Dear reader,

- this piece of work is focussed on rewriting the frontal and rear impact;
- to keep an overview nothing of the old text is deleted but in strikethrough characters;

Hans Ammerlaan - NL MOT/RDW

## 7. PARTICULAR SPECIFICATIONS

Figure 1

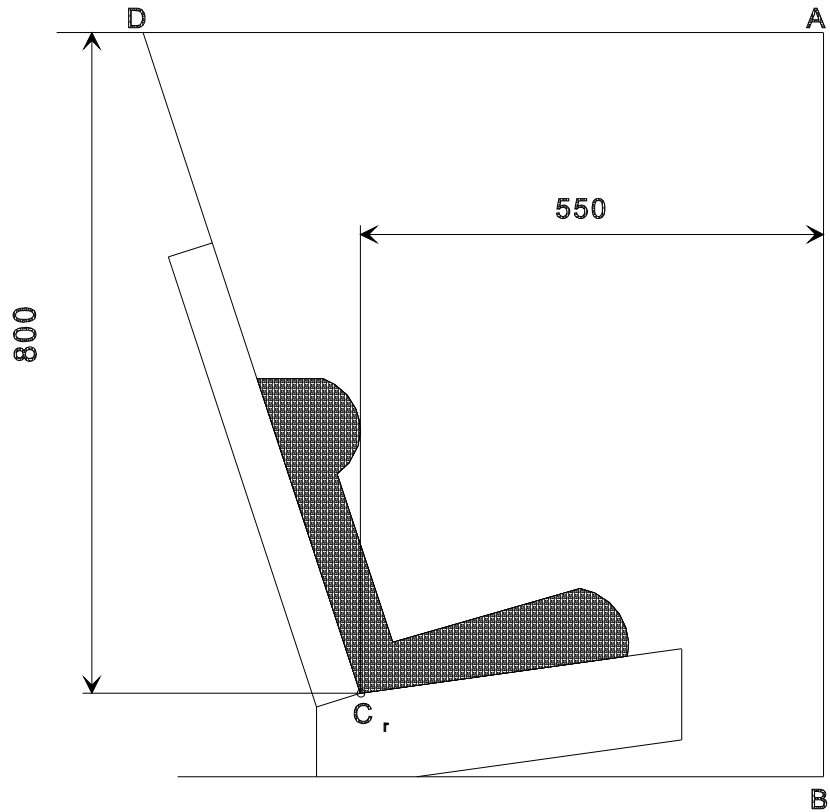
*Remark: as is the case with rearward facing child restraints, the point E being the top of the seat back of the R.44 seat should also be defined here.*

Furthermore, because it concerns ISOFIX child restraints, the forward excursion limit shall have to be changed from 550 mm to 500 mm.  
Finally, the 800 mm vertical limit shall have to be connected to only testing with Q0, Q1, Q1.5, Q3 and Q6, whilst for testing with Q10 a vertical limit of 840 mm will be used.

Head excursion: no part of the head of the manikin shall not pass beyond the planes BA, ~~and~~ DA and DE as defined in Figure 1 below. This shall be judged up to 300 ms or the moment that the manikin has come to a definitive standstill whatever occurs first.

Figure 2:  
Arrangement for testing  
a rearward-facing device

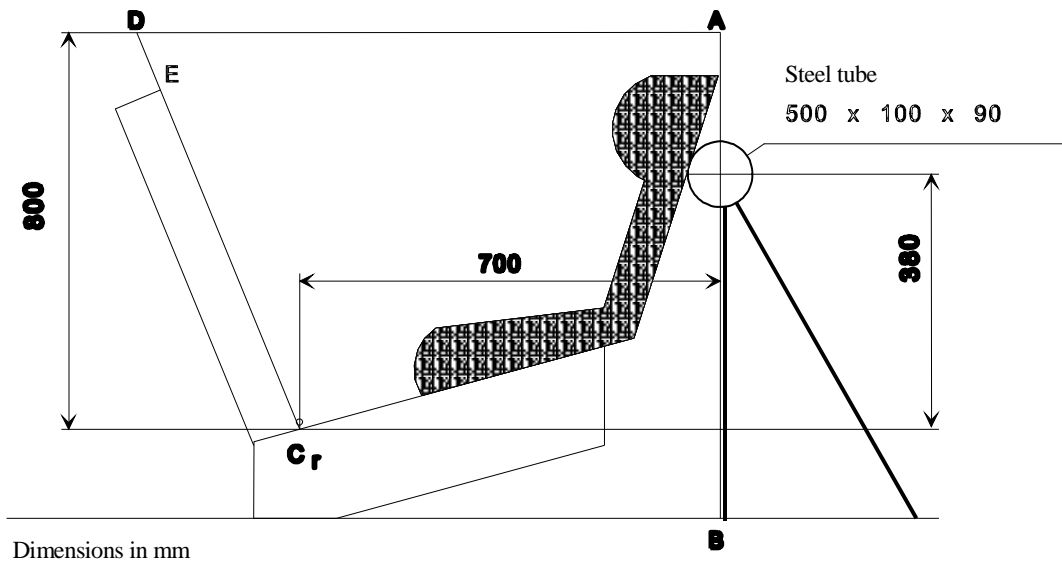
*Remark: figure below with support by dashboard not needed anymore must be deleted*

Figure 3

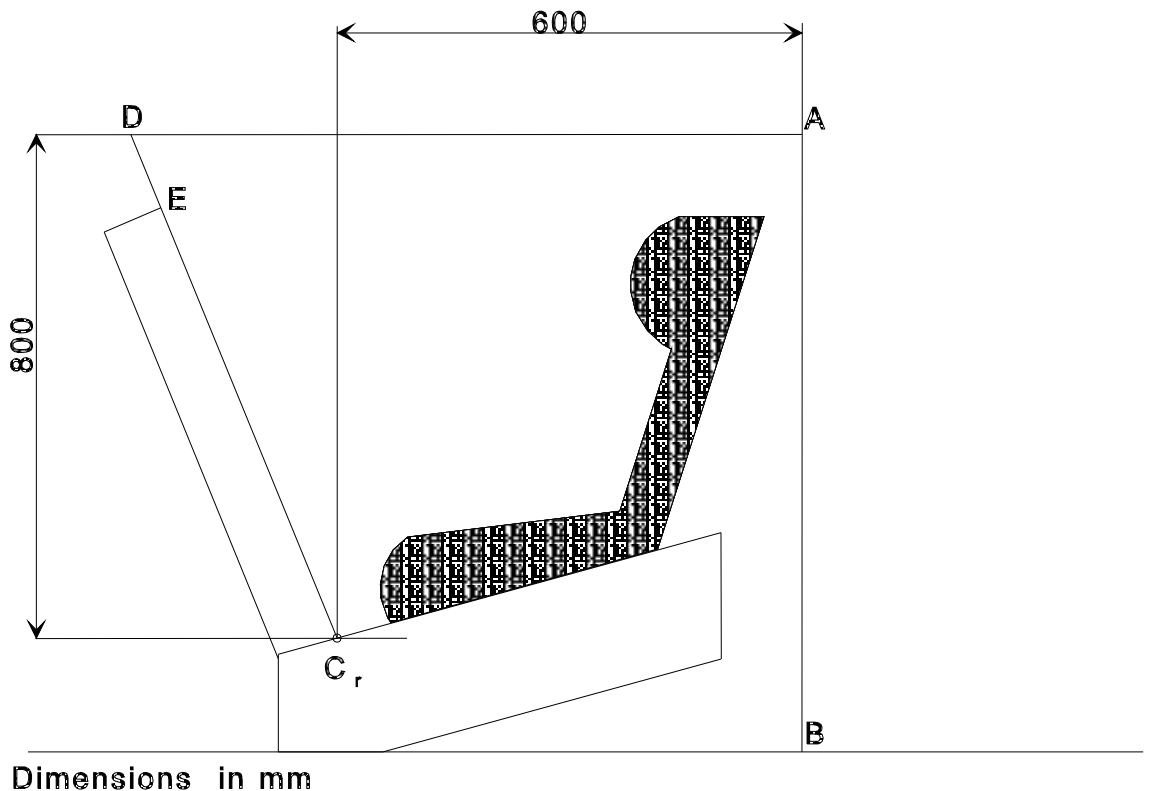
*Remark: figure below with distance of 600 not needed anymore must be deleted*

**Figure 4:**

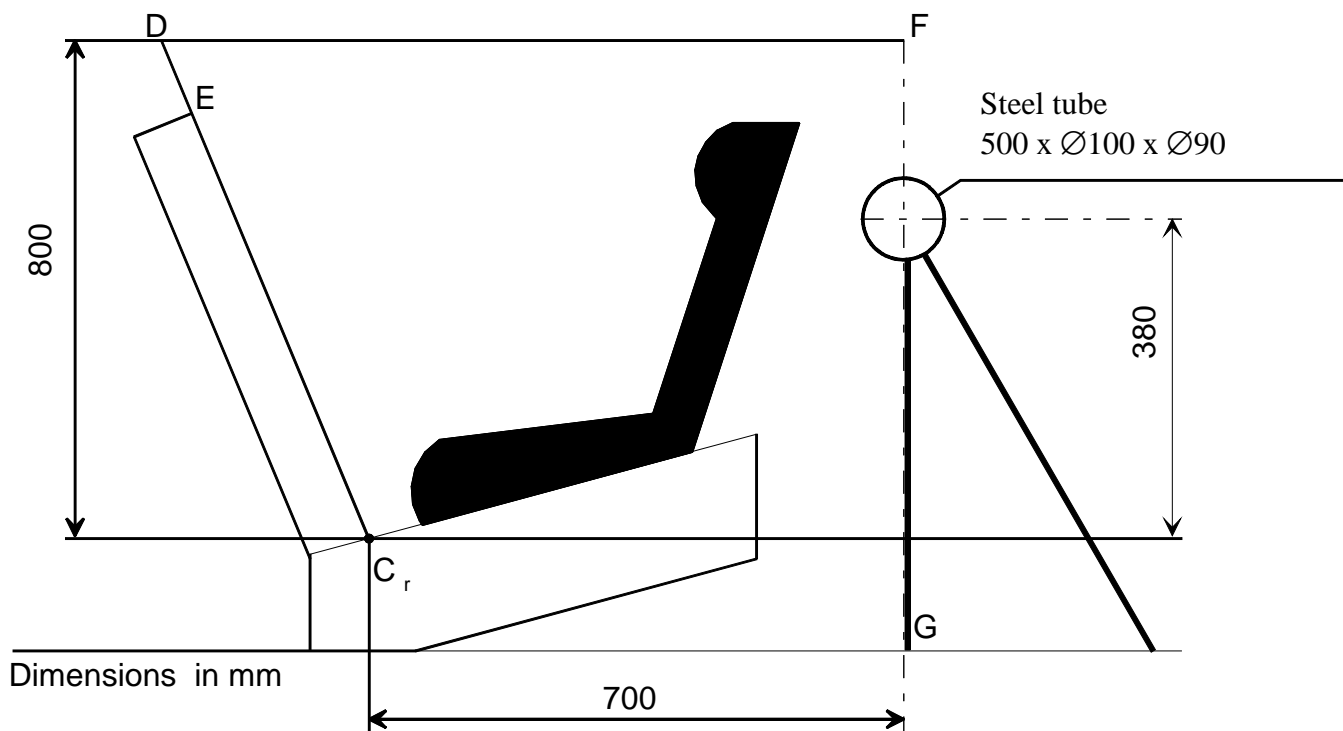
*Remark: now from the point of view that a distance from Cr point to dashboard of 700 mm will be an accepted measure, it should be safeguarded that front passenger car seats can offer this space (after normal adjustment of the seat).*

7.1.4.4.1.2.2. Head excursion: no part of the head of the manikin shall not pass beyond the planes FD, FG and DE, as shown in Figure 4 below. This shall be judged up to 300 ms or the moment that the manikin has come to a definitive standstill whatever occurs first.

In the case there is a contact of such a child restraint with the 100 mm diameter bar and all performance injury assessment and manikin's head displacement criteria are met, there shall be one further dynamic test (front impact) with the heaviest dummy intended for such child restraint the given iSize indication and

**CURVE OF RELATIVE VELOCITY BETWEEN TROLLEY AND DOOR PANEL  
AS FUNCTION OF TIME**

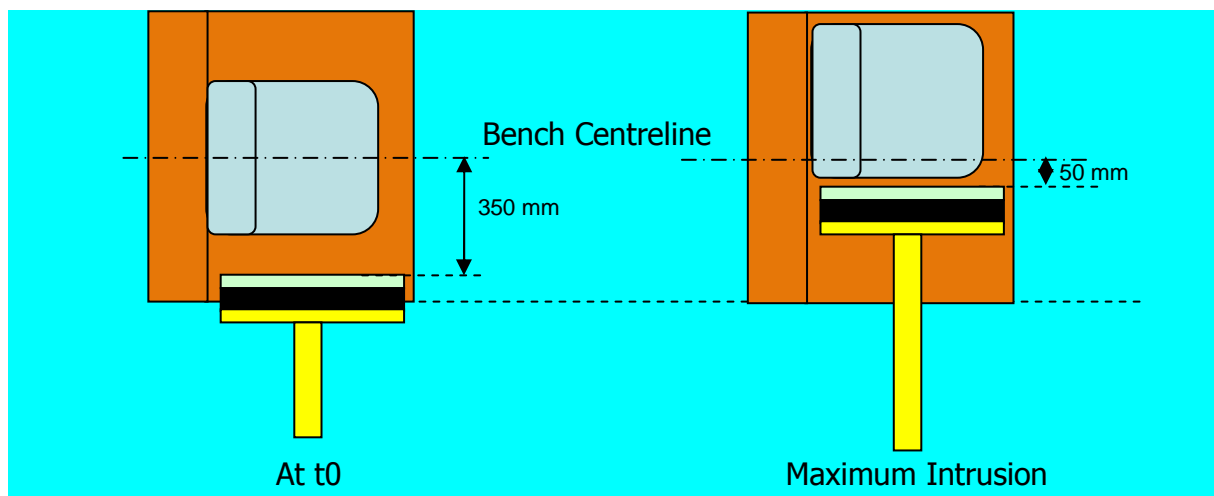
Remark: The corridor must be defined on experiences of respective test labs.

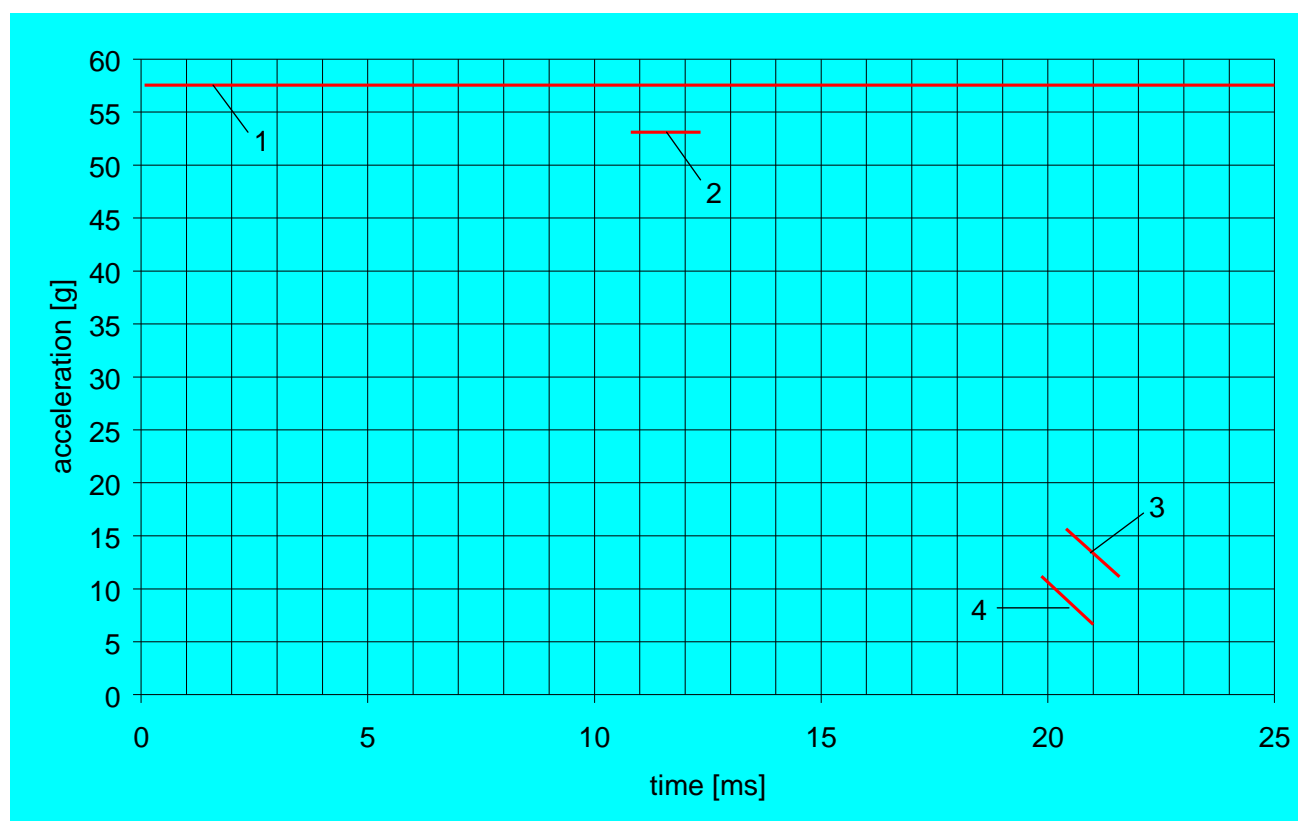
*The door panel geometry must be in line with the bench definition  
Drawing to describe the door will be proposed in line with the NPACS Bench*

The door panel is padded with 55 mm padding material, which has to comply with the performance criteria as described in Annex X 2.3 realised in a test set up as described in Annex X 2.2. Finally an example for material meeting the requirements is described in Annex X 2.4.
